LEADEN HALL PLANNING APPLICATION PL/2024/00373

We are writing to let you know that Chapter have recently submitted a planning application for the conversion of Leaden Hall to provide office accommodation for their staff.

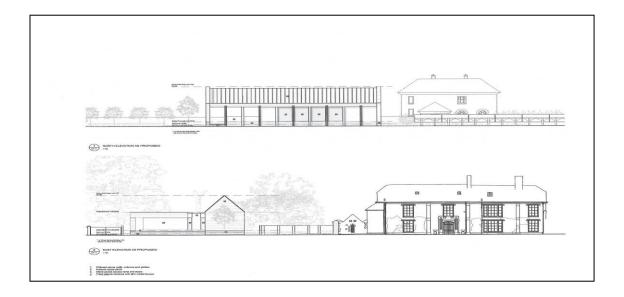
The Planning application includes a comprehensive theoretical flood risk assessment, but this desk-based analysis seems to ignore the observed reality that the proposed site of the new archive and the solar panels lie within an area with a current history of very high flood risk as the photographs taken this January illustrate.

We contend that there must be an alternative site for the precious archives of the Cathedral. It cannot be wise to locate these heritage assets in an area so obviously at risk.
